SIB 12 12 20

RECALL 20V-761: CHECK 48 V CABLE CONNECTIONS TO THE STARTER GENERATOR (SGR)

This Service Information Bulletin (Revision 2) replaces SI B12 12 20 **dated December 2020**.

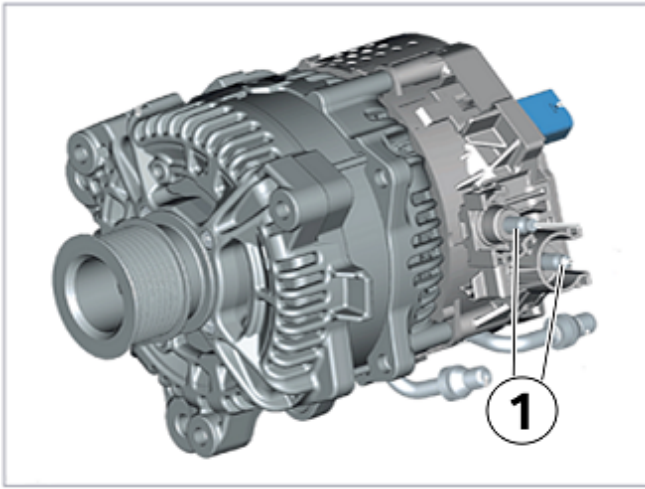
Check the positive (1) and negative (2) cables for play at the mounting lugs on the SGR.

If there is play in the connection to the SGR –

- Deactivate the 48 V electrical system (Repair instruction REP-TAT-P-6124-18-B47_48V)
- Remove and discard the flange nut on the B+ or B- cable.
- Install a new flange nut so that it’s carefully started by hand to avoid cross-threading
- Torque to 19 Nm
